CITY OF IQALUIT  
WATER LICENCE 3AM-IQA1626  
**2023 Annual Report Review Response**

November 01, 2024

## CIRNAC COMMENTS ON THE 2023 ANNUAL REPORT

**Figure 4.2 10% of Flow at WSC Station 10UH015 and Daily Average Pumping Rate**

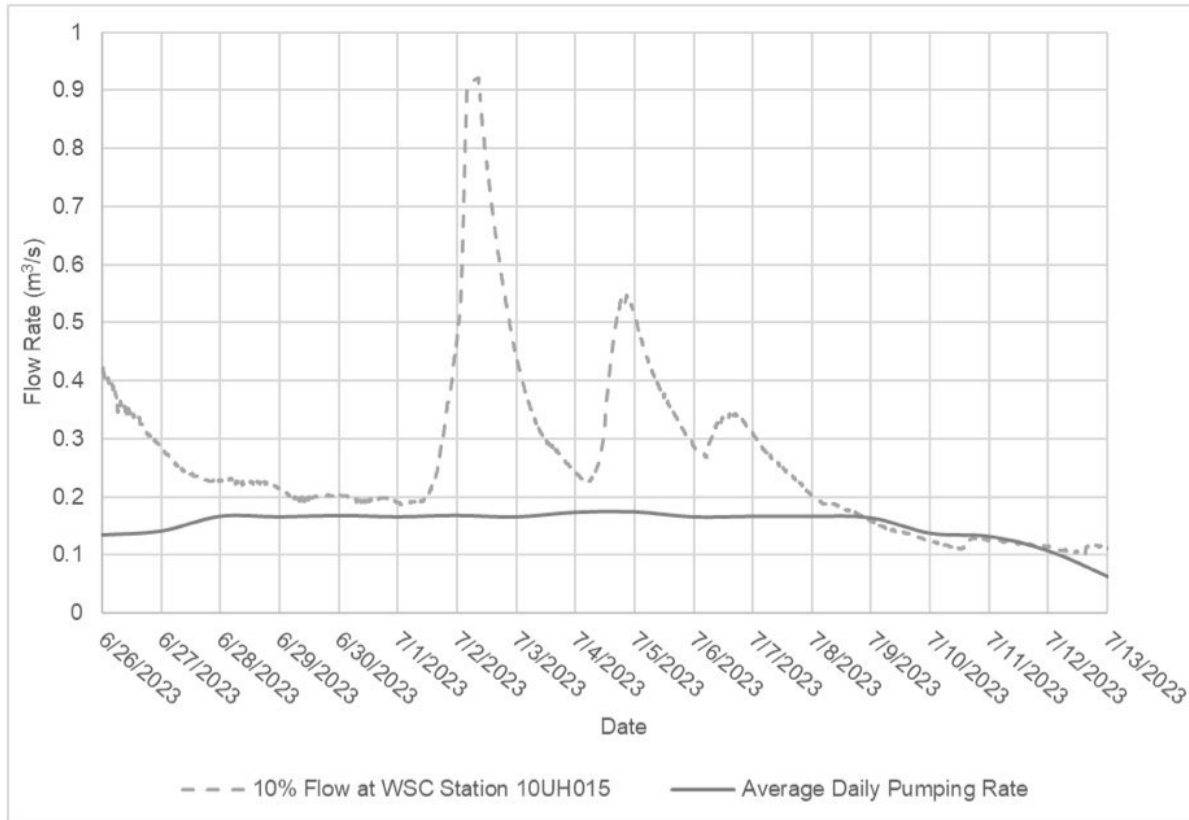
The 2023 Apex Pumping Final Report includes discussions on exceedances and visualizations where pumping exceeded 10% of the instantaneous flow in Figure 4.2. However, the impact of these exceedances is not fully detailed, with the report merely stating that no harmful impacts were noted. This falls short of CIRNAC's 2022 recommendation (R208b) to include a detailed discussion of observed trends, exceedances, and unanticipated impacts, especially when natural flow is below 30% of the mean annual discharge (MAD) and withdrawals exceed 10% of the instantaneous flow. The City had previously requested a meeting to collaborate with CIRNAC to determine the appropriate format and approach for this discussion. It would be beneficial to follow up on this meeting to ensure comprehensive coverage of these aspects.

(R-13) CIRNAC recommends the City of Iqaluit provide a detailed analysis of the monitoring data that supports the conclusion of no harmful impacts, and provide information on the methods used to assess potential impacts and any specific observations or findings related to ecological effects.
